DELEGATED REPORT

FILE: OPW/21/0006

APPLICATION		PREMISES	
FILE NO:	OPW/21/0006	ADDRESS:	2-4 Quill Street, Mareeba
APPLICANT:	Conmat No1 Pty Ltd	RPD:	Lot 22 on SP217220
LODGED BY:	ERSCON Consulting Engineers	AREA:	8,401m ²
DATE LODGED:	17 April 2024	OWNER:	Conmat No1 Pty Ltd
TYPE OF APPROVAL:	Development Permit		
PROPOSED DEVELOPMENT:	Operational Works (Bulk Earthworks, Drainage Works and Access & Services Infrastructure)		
PLANNING SCHEME:	Mareeba Shire Council Planning Scheme 2016		
ZONE:	Low Density Residential zone		
LEVEL OF ASSESSMENT:	Code Assessment

The development application seeks a Development Permit for Operational Works (Bulk Earthworks, Drainage and Access Works)

COMMAT PTY LTD
 QUILL STREET LAND DEVELOPMENT
 GENERAL LAYOUT PLAN
 160-001-C-103

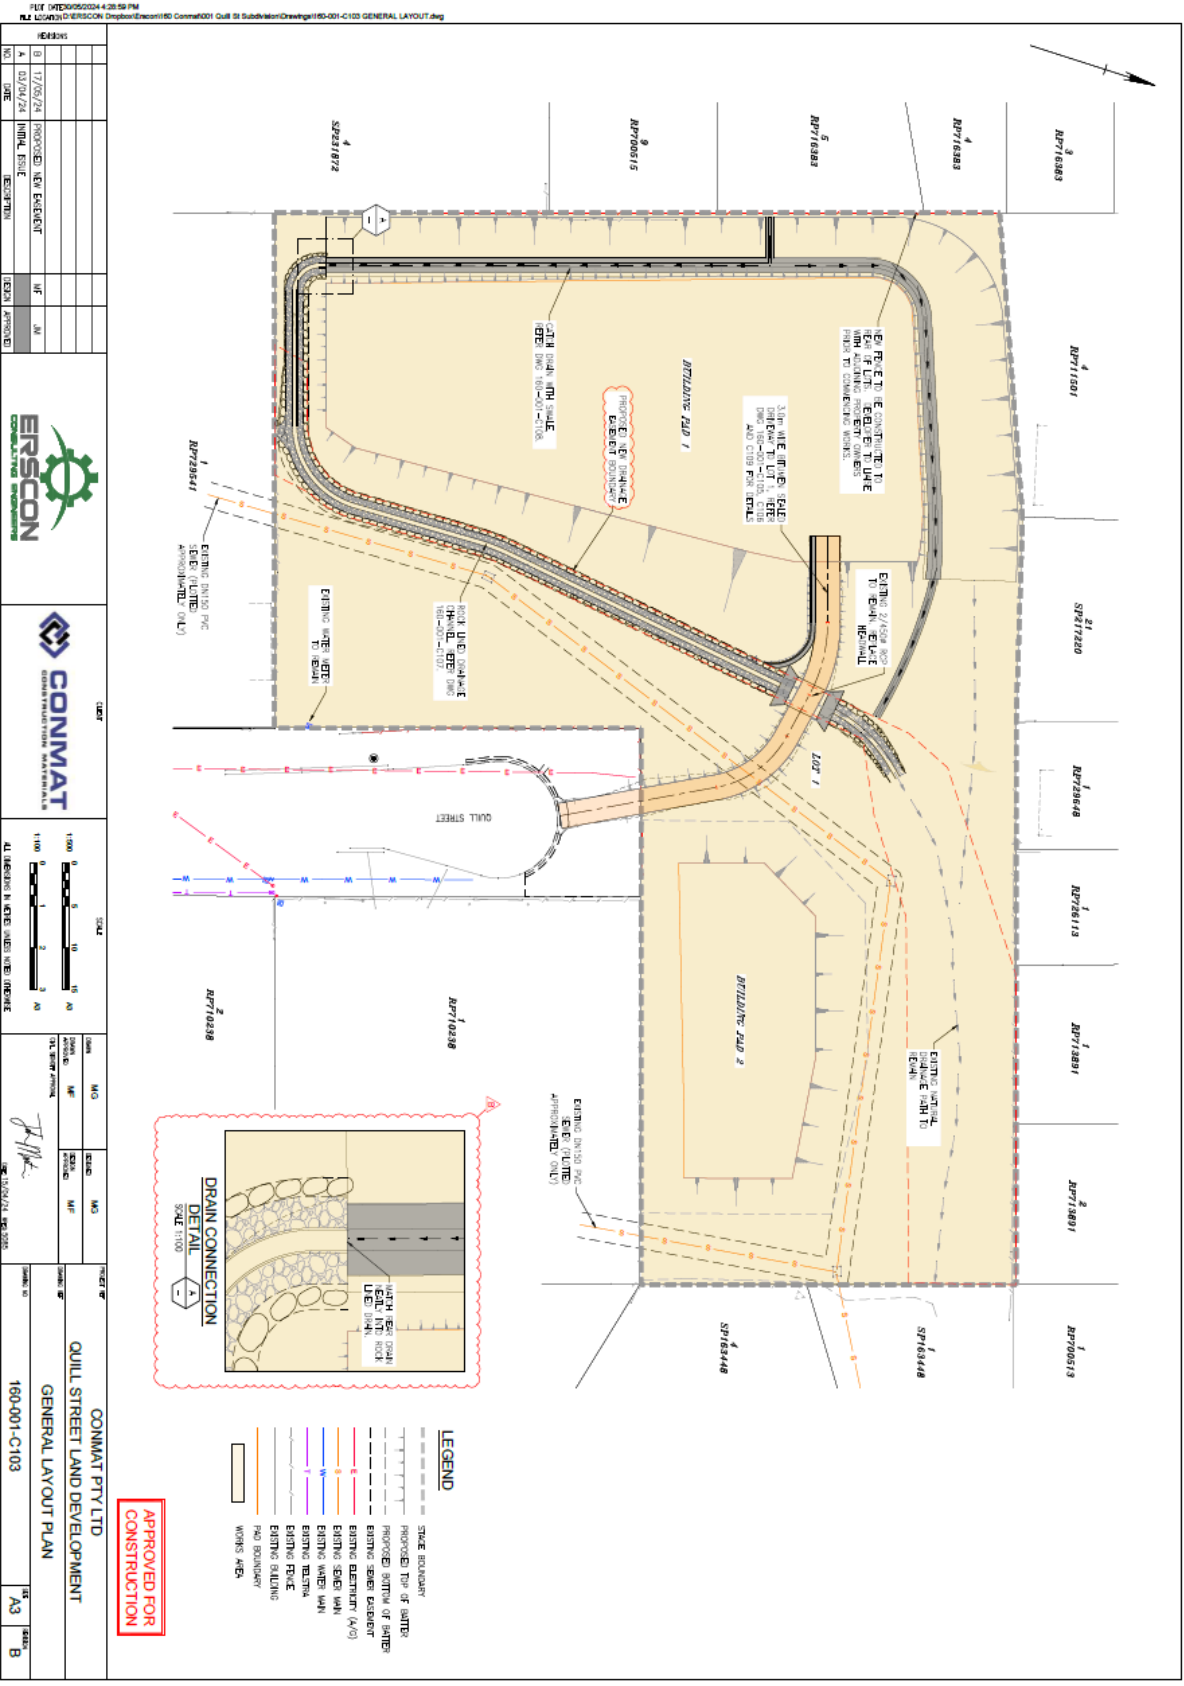
The drawings must be amended to show the location and extents of the existing drainage easement through the property overlaid on the General Layout Plan and site Grading Plan.

Any changes to the existing drainage easement to reflect the footprint for Building Pad 1 must be shown on the site general arrangement plan and submitted for approval by Council.

PROJECT: **CONMAT PTY LTD
 QUILL STREET LAND DEVELOPMENT
 GRADING PLAN**
 REF: A3

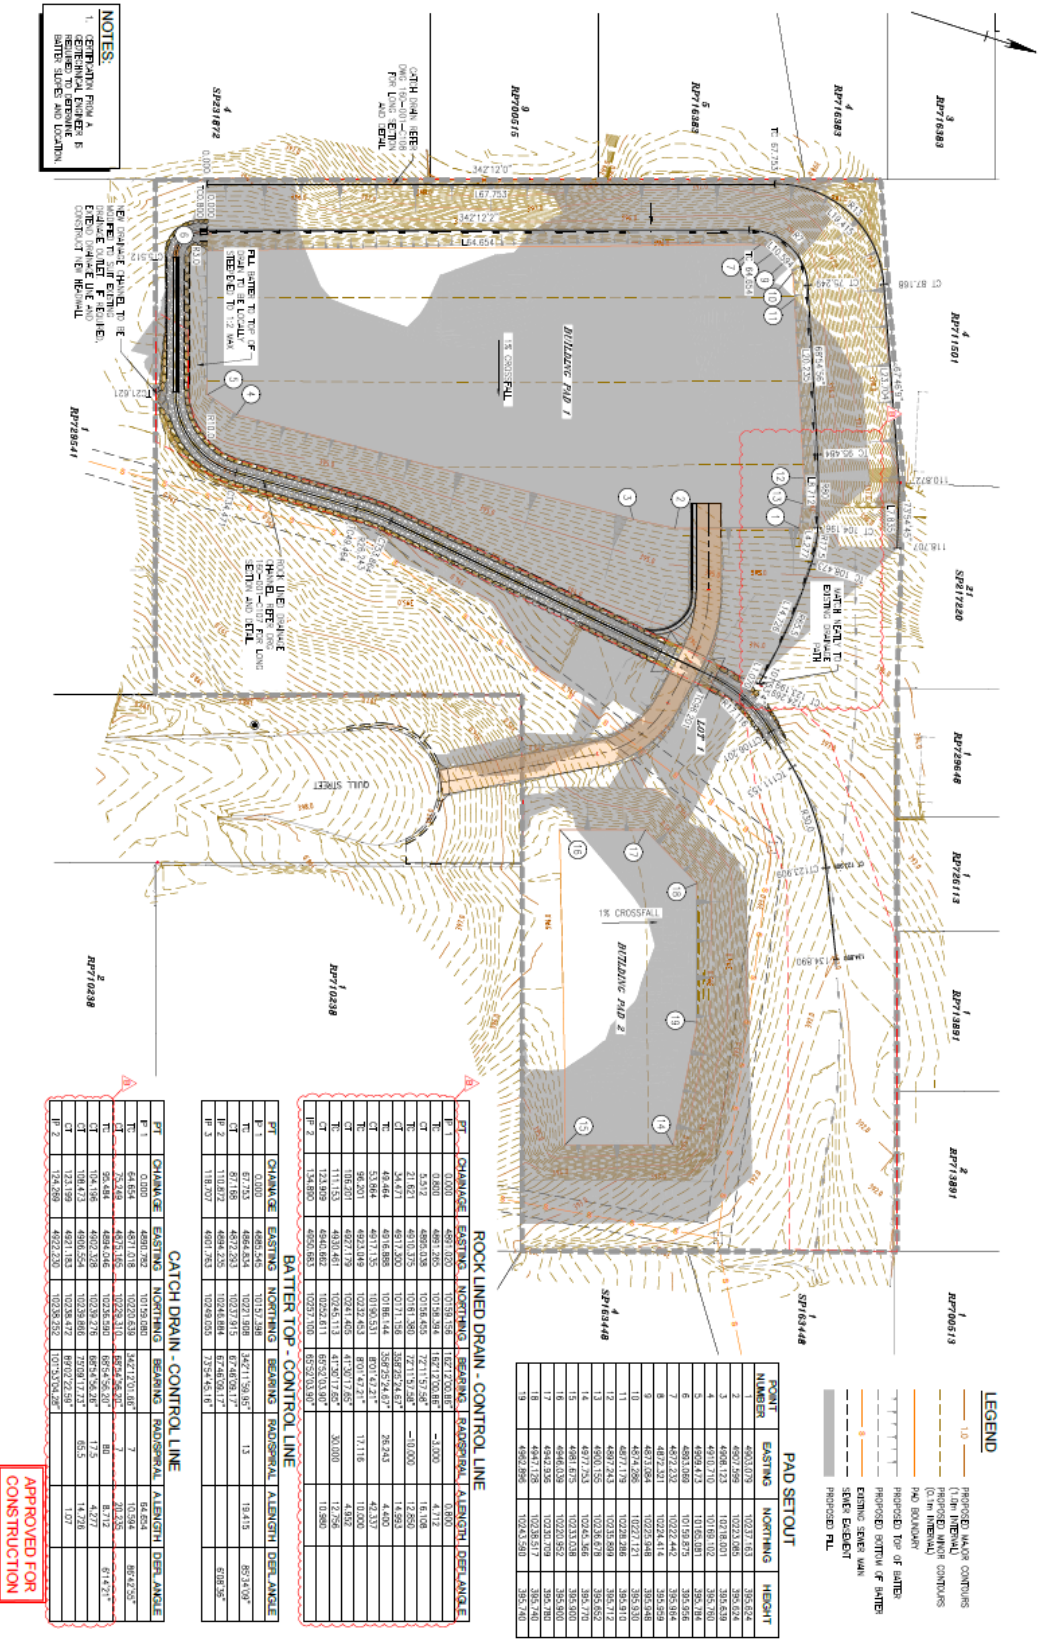
Prior to excavating the northern and western batters for proposed Building Pad 1, the applicant must provide a geotechnical report to determine batter profile and stability.

The final location of the catch drains on the northern and western sides of Building Pad 1, will be subject to confirmation of the batter profile by the site-specific geotechnical report.

The site-specific Geotechnical Assessment must be prepared by a suitably qualified Geotechnical Engineer (RPEQ). The report must assess the risk of the land and proposed batter profiles for this development in accordance with the AGS Guidelines 2007.

Any changes required to batter profiles to achieve this outcome must be included in the report and documented on amended drawings submitted to Council for approval.

CONMAT PTY LTD
 QUILL STREET LAND DEVELOPMENT
 DRIVEWAY PLAN
 160-001-C105

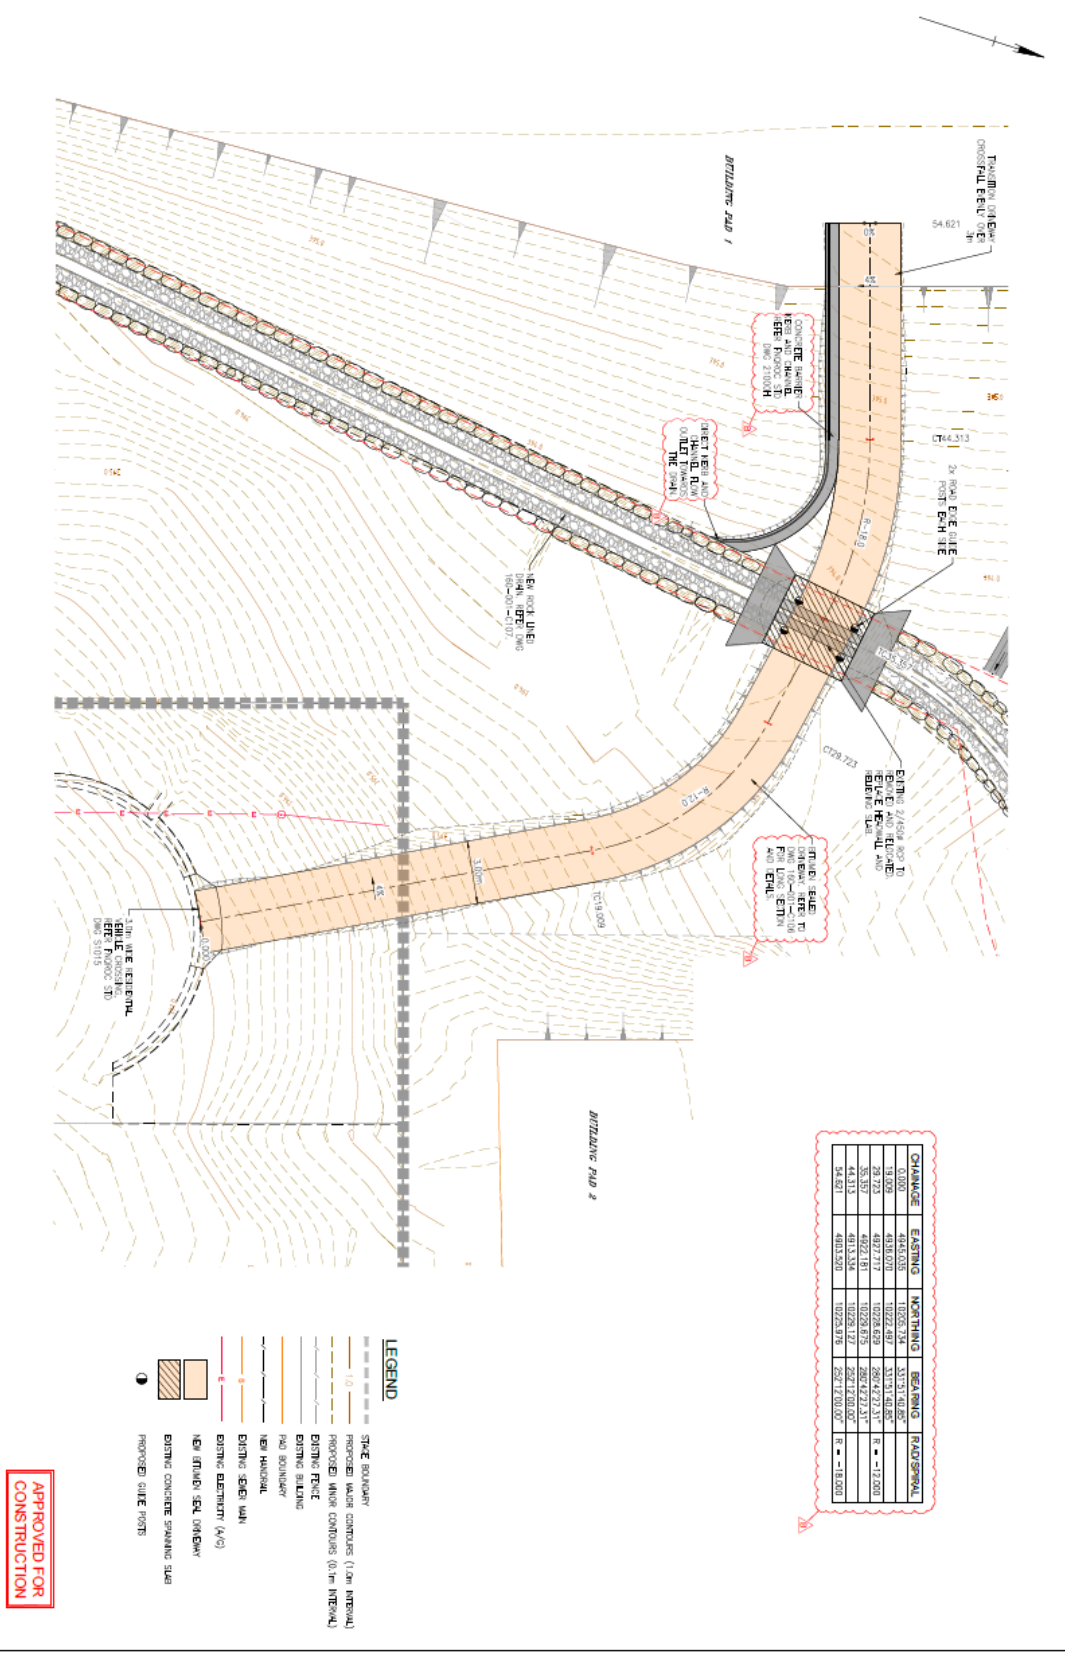
This Decision Notice approves construction of the driveway to Building Pad 1 in accordance with ERSCON Consulting Engineers Drawings 160-001-C105 and C106 Revision B.

The proposed driveway to Building Pad 1 does not achieve immunity or trafficability for the 1%AEP Flood Event for the Barron River, being inundated by approximately 1.8m. The driveway is considered suitable for single lot access only (noting Building Pad 2 accessibility during Barron River flooding). Any further development on the land must consider this flood immunity limitation of the driveway.

The proposed driveway access at Quill Street must ensure stormwater runoff in the Quill Street kerb line is not directed down the driveway to the drainage easement. The driveway crossover is to be regraded to have positive fall back to the kerb line and ensure runoff is directed to the existing kerb break west from the driveway.

The current driveway grading away from the kerb invert appears to accept runoff from the eastern kerb of Quill Street down the driveway.

The proposed driveway and driveway grades within Quill Street appear to grade from the kerb invert down into the site.

If this is the design intent, the applicant must provide kerb and channel on the driveway from the Quill Street kerb line to the new rock lined drain in the existing drainage easement.

The driveway must also be included in a new easement for stormwater purposes reflecting its function to convey stormwater runoff from the road reserve to the existing drainage reserve.

The applicant is advised that any intensification of the uses for this site may require the verge to be reconstructed to achieve a compliant verge grade for pedestrians, services, bin storage and car parking to service the additional demand from a new use.

The driveway may need to be considered to avoid the requirement for rework in the future.. Any changes proposed to the current driveway design must be provided prior to the Pre-start Meeting.

PROJECT NO.	160-001-C109
PROJECT NAME	QUILL STREET LAND DEVELOPMENT SEWER RETICULATION PLAN
SCALE	A3
DATE	B

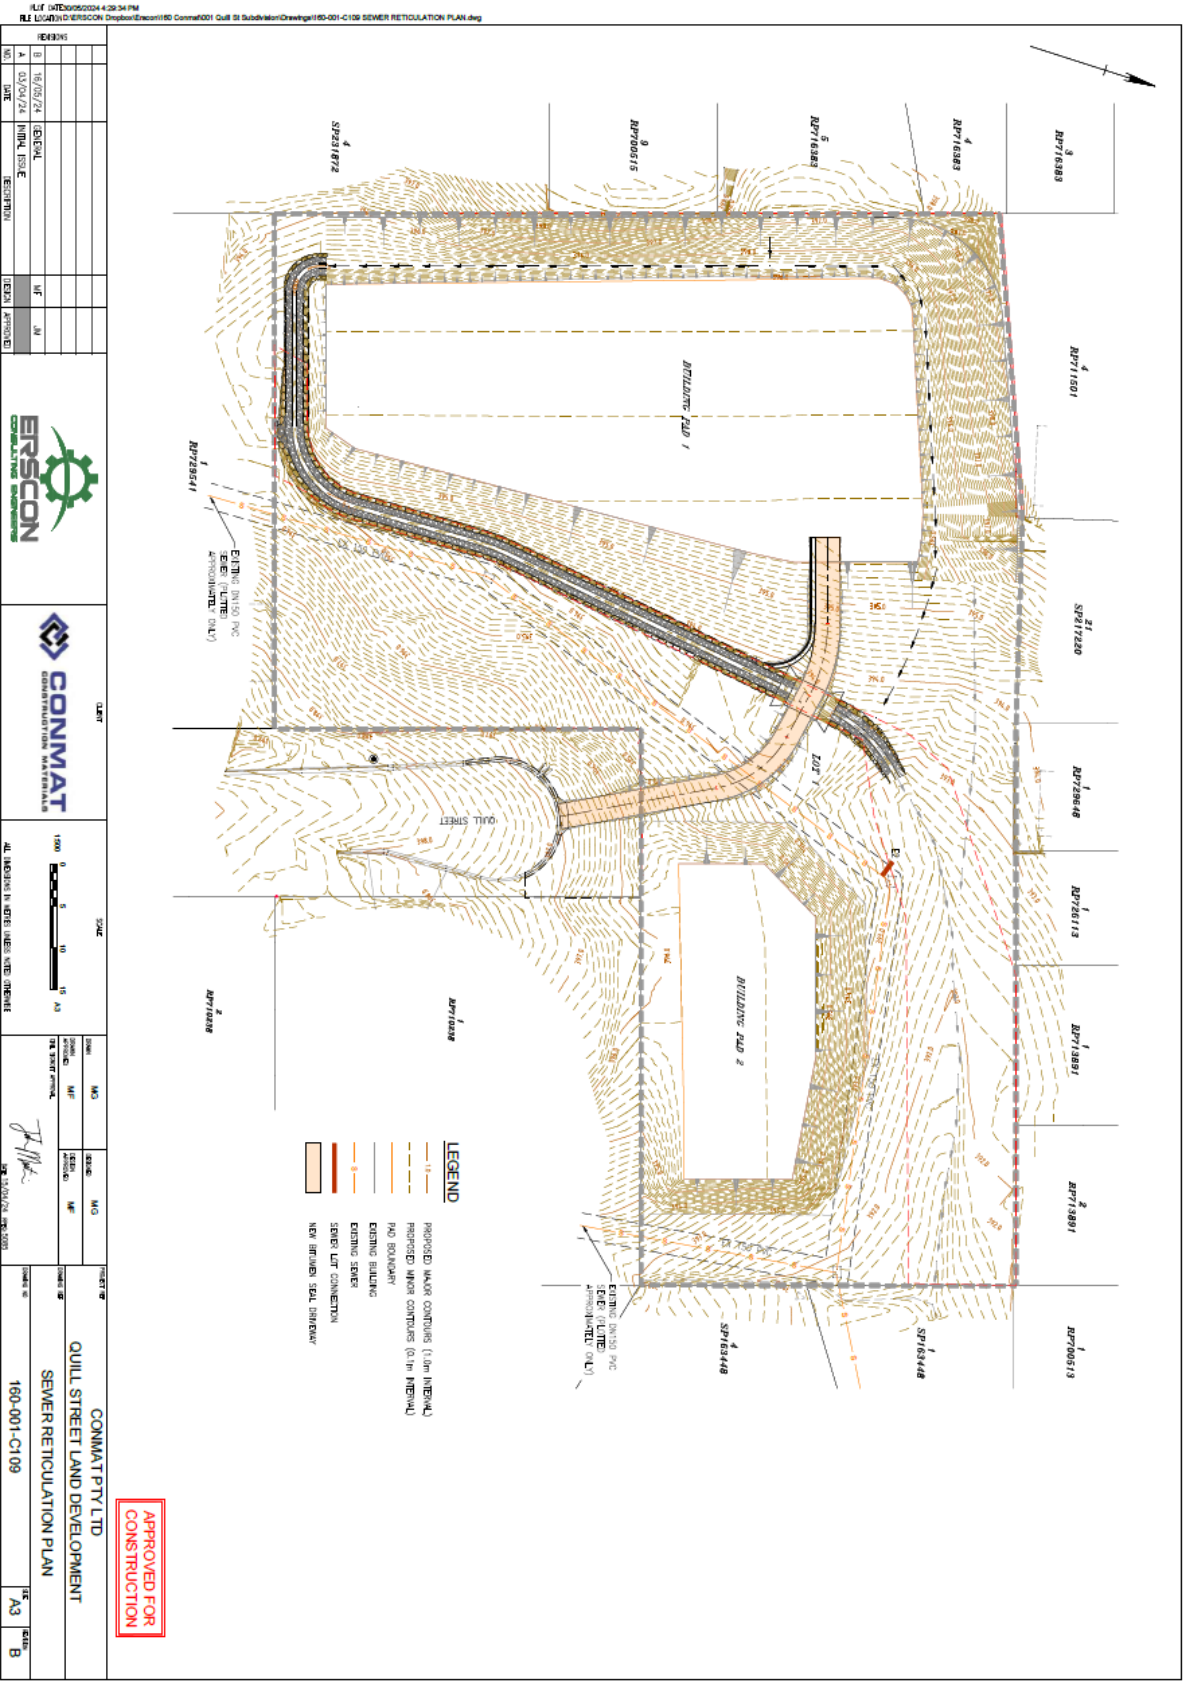
The proposed sewer lot connection must be completed under Council supervision. Unless otherwise approved by Council, the E2 type sewer connection must be a stainless-steel sewer offtake clamp.

Advice note: *The sewer connection point is below the 1%AEP flood level and the stainless-steel sewer offtake clamp is nominated to reduce risk of infiltration at the connection cut in point.*

If the applicant proposes to construct the sewer connection to Building Pad 1 under the current work scope (prior to drain lining), amended plans must be provided and approved prior to construction of the works.

Future connection to service either building pad must be completed under a plumbing application and will be required to achieve minimum cover to the drain lining.
